July 19, 2019

ADDENDUM NUMBER TWO (2)

Project: Ridgeland City Hall
 City of Ridgeland
 PN: 14084

FROM: Dean and Dean/Associates Architects, P.A.
 4400 Old Canton Road, Suite 200
 Jackson, MS 39211
 (601) 939-7717

1 SITE PLAN - ELECTRICAL (BASE BID)
E1.1 SCALE: 1"=30'-0"

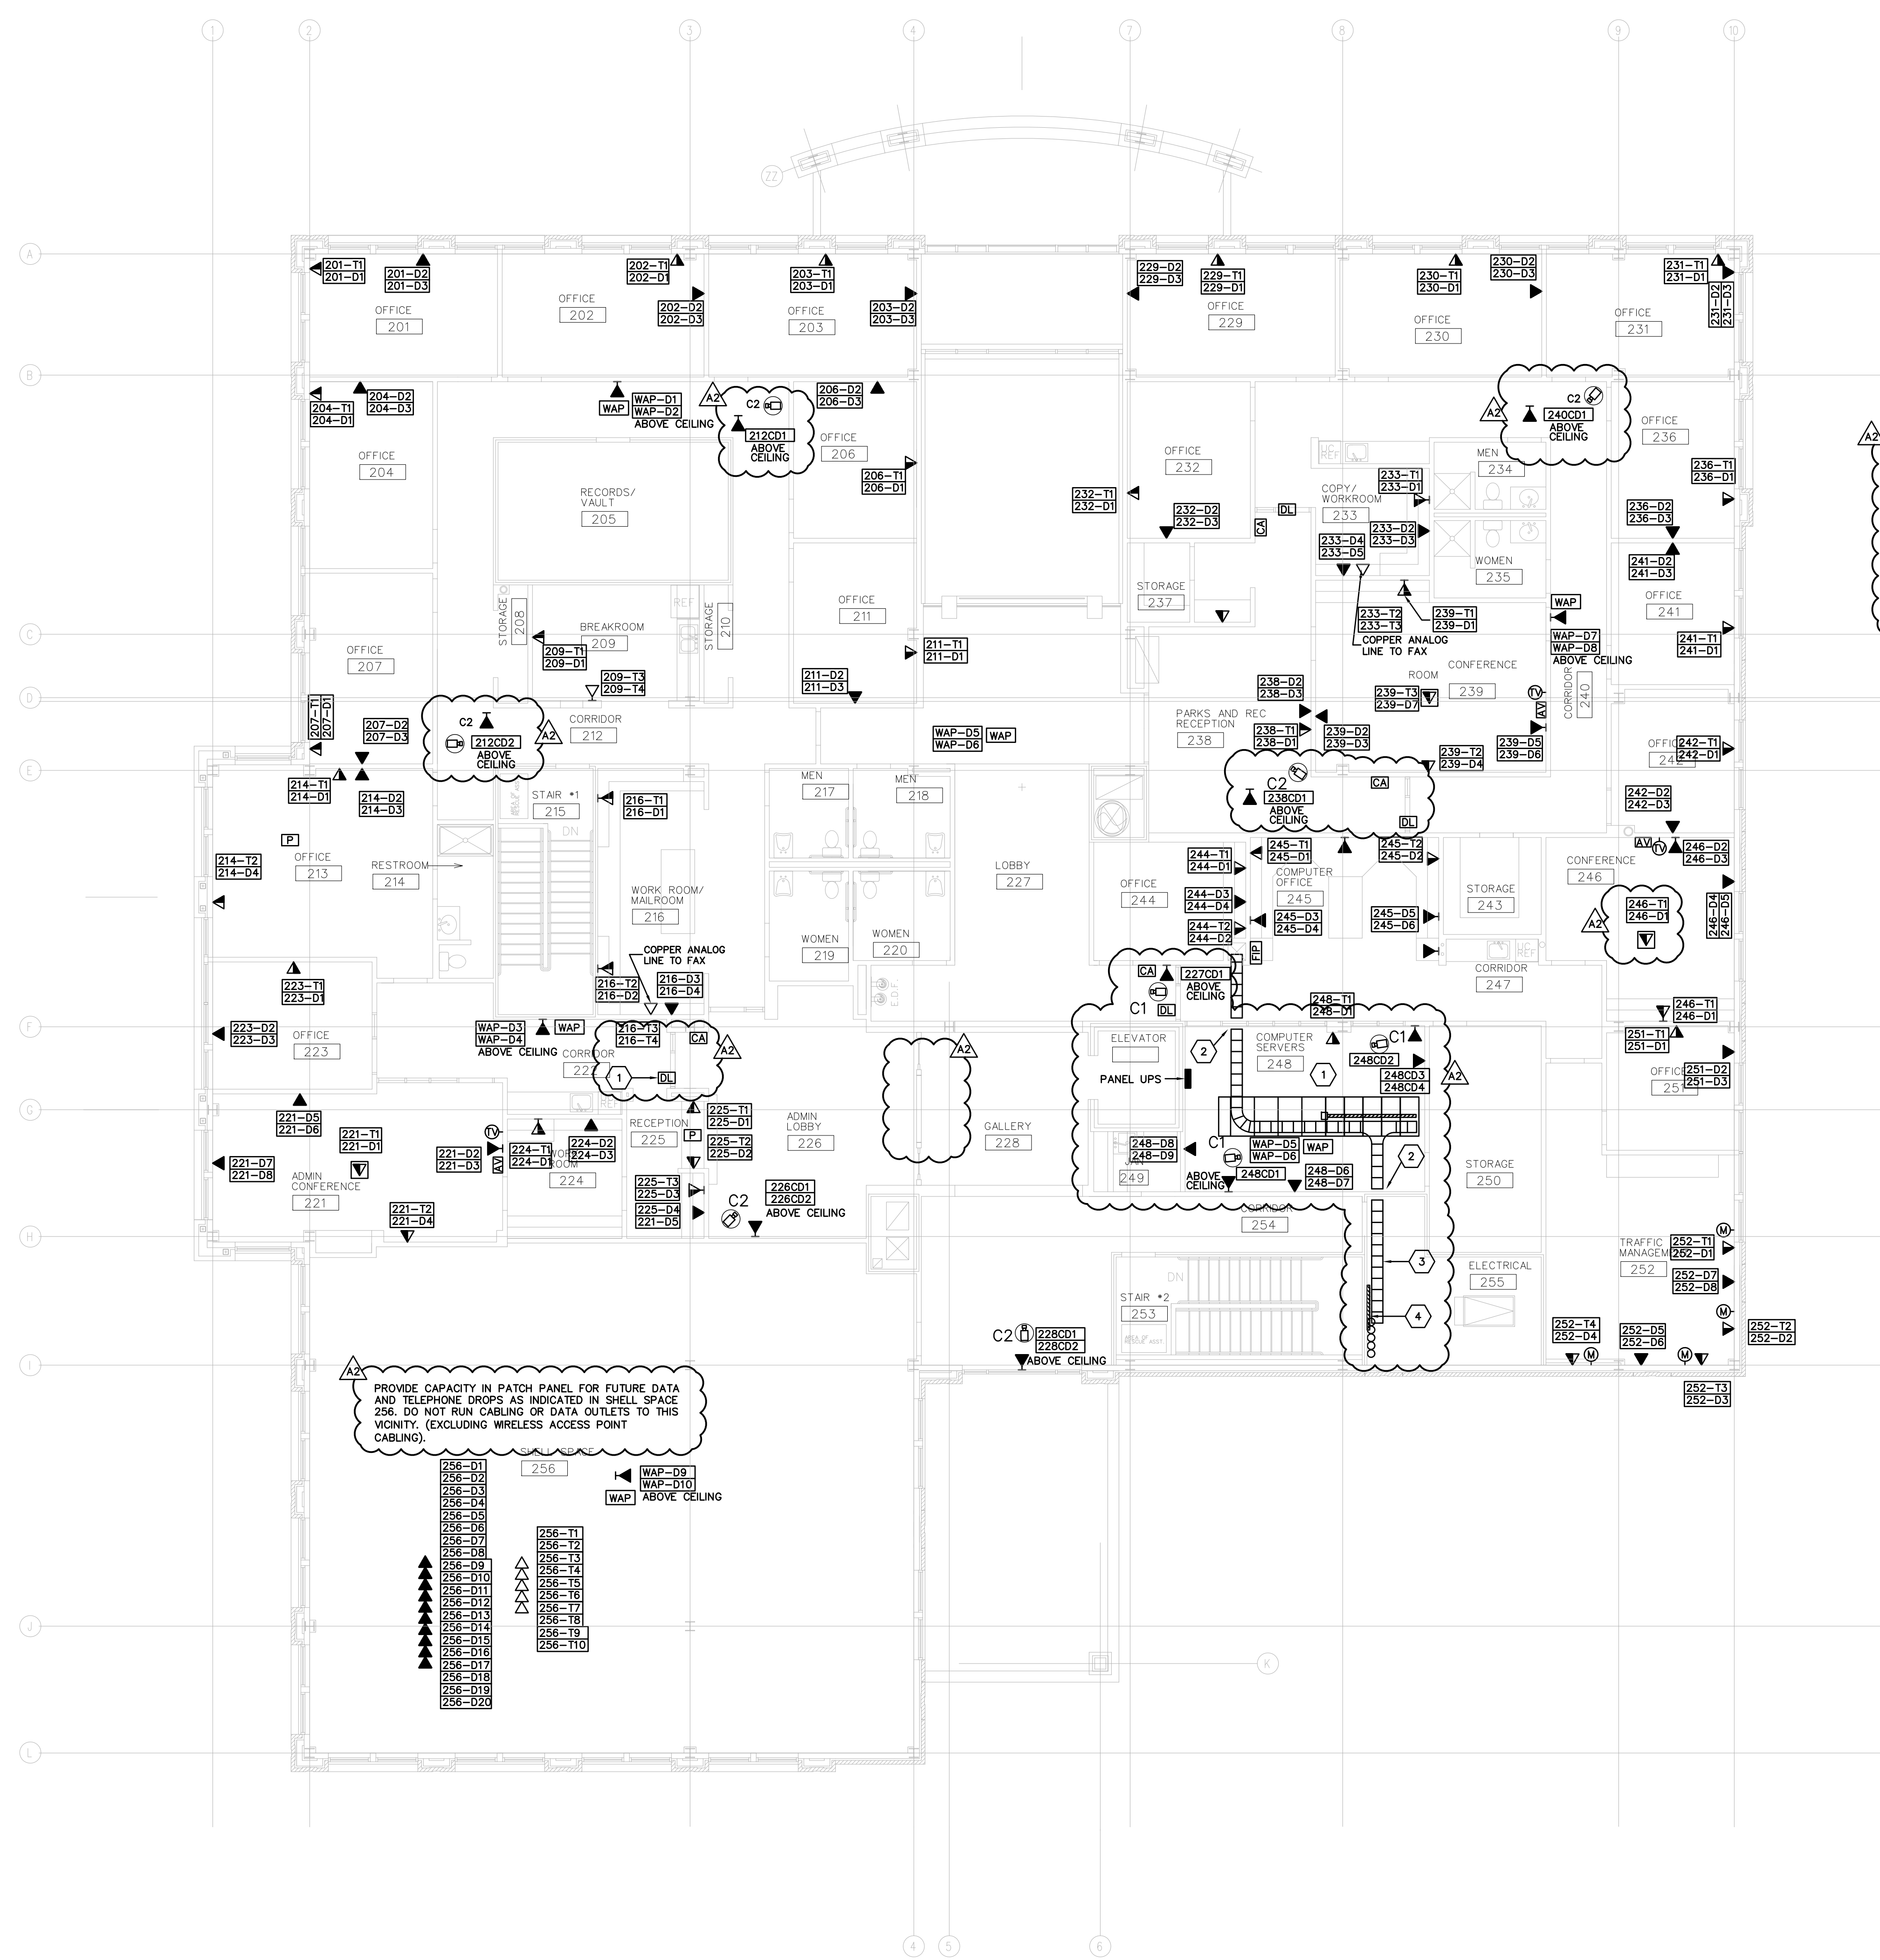
1. A tamper switch for monitoring the post indicator valve has been added.
2. The Pole Bases for Fixture Types SL1A and SL1B shall be installed per Detail 1/Sheet E0.5 The Pole Bases for fixture Type SL4 shall be installed per new pole base detail

1 SECOND FLOOR PLAN - SYSTEMS
E4.2 SCALE: 1/8"=1'-0"

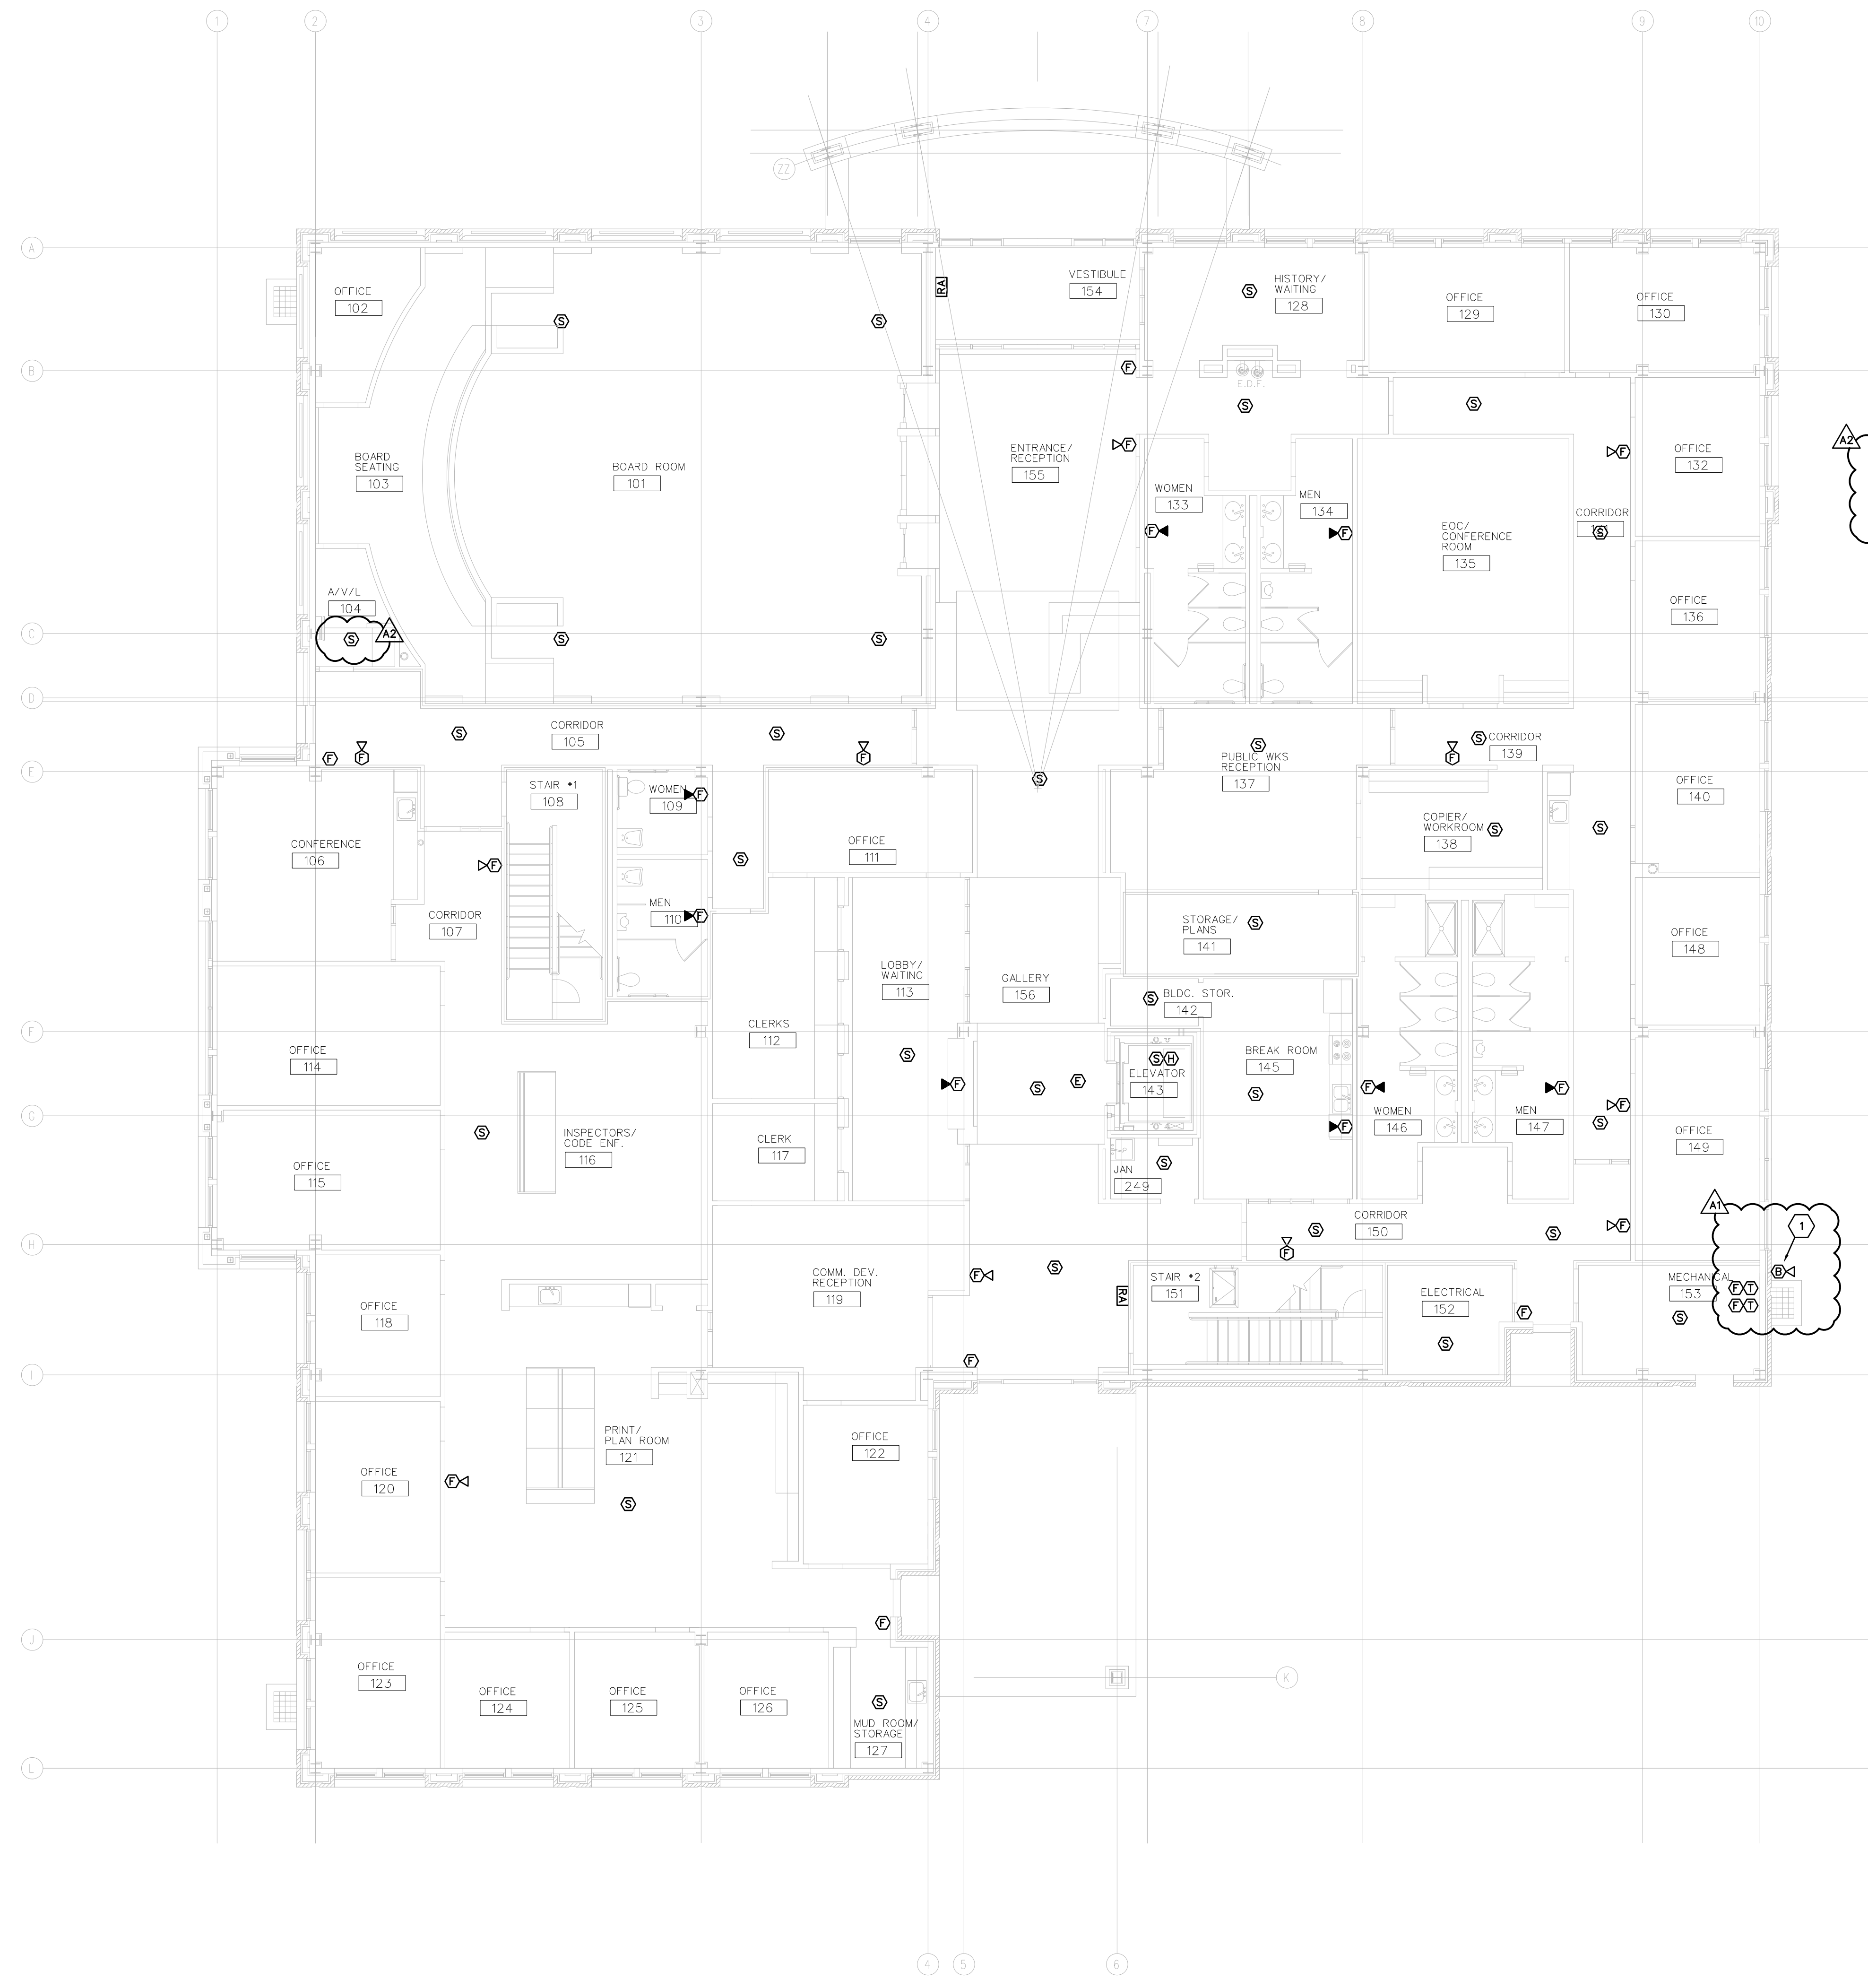
1. Cable tray passing through Computer/Servers 248 shall not pass through walls of Computer/Servers 248. Stop Cable tray short of each side of wall and provide Four 4" Sleeves and fire caulk sleeves and conductors after installation of all conductors.

2. Access control in Administration Lobby 226 moved from door 226A to 226B.
3. Access Control has been added to door 240A in Parks and Rec Reception 238.

4. UPS/IT rack, and Cable Tray has been modified. Panel UPS has been located on the drawings.
5. Cable Tray shall be 18"W x 4"D basket type tray, with center hung support. Provide tees and offsets as required.

6. Data Port labeling has been provided for the Security Cameras. Security Cameras shall have one Cat 6 cable data connection.
7. Wireless Access points have been adjusted and have been provide with data port labeling. Wireless Access Points shall have two Cat 6 data connections.

8. Provide ground bus bar on standoff at telephone backboard. Connect to building system ground at Main Distribution panel with #4 AWG grounding conductor.
